Subject: R1-2017-0005_Fortuna_Permit_comments

The City of Fortuna (City) would like to thank the Board for giving us the opportunity to review and provide comments on the draft NPDES permit for the City's wastewater treatment plant discharges. This new permit reclassifies the City's percolation ponds into NPDES discharges and adds new, very stringent effluent limitations. The City will need time to upgrade our treatment plant to meet these limits year round. Therefore, the City asks that a compliance schedule be provided in the permit instead of in a companion Cease and Desist Order (CDO) or Time Schedule Order (TSO), which provide no protection from citizen lawsuits for permit violations that might occur while the City is constructing new treatment upgrades. We have provided specific permit language in the attached redline version of the permit to assist your staff with fulfilling this request.

EXHIBIT C

City of Fortuna Wastewater Treatment Plant Discharge and Sampling Points

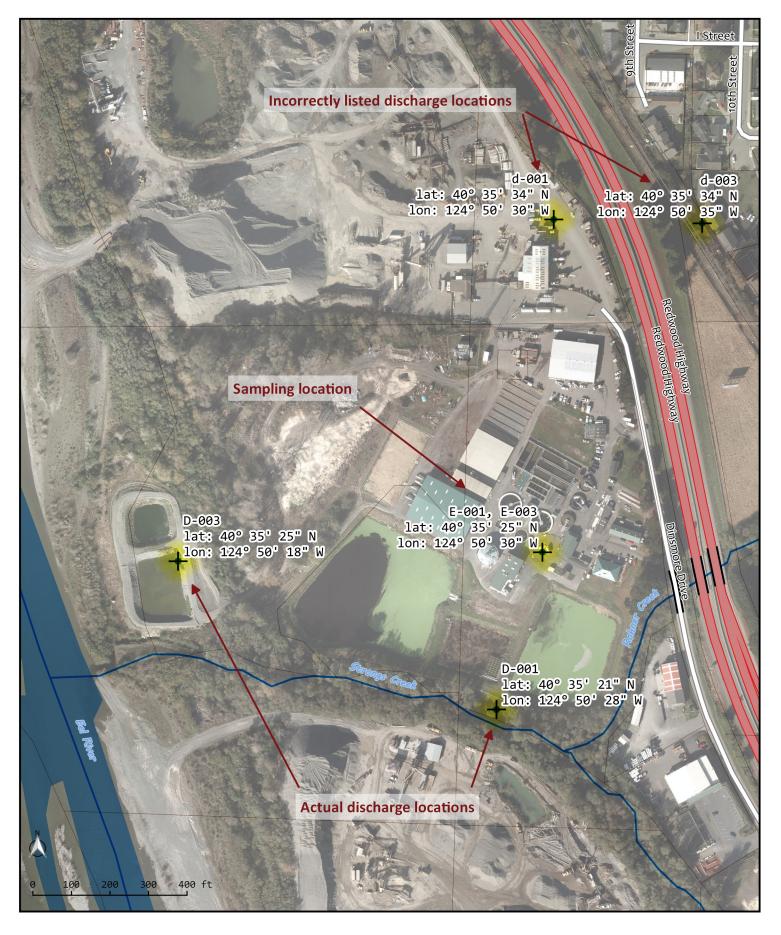
- Reducing the monitoring locations to a single location since there are now no differences in the treatment for land or water discharge. We have provided a new map with latitude and longitude indicated for the monitoring and discharge locations that should be incorporated into the permit. See Exhibit A.

- 1. Table 2 Discharge Locations; Discharge Points GPS locations do not represent actual location. See attached map. There's a difference between Monitoring points E-001/E-003 and Discharge Point 001/003. E-001/003 is located up near the operations building where the valves are that switch locations but the Discharge points are at Strongs Creek and the Percolation ponds.
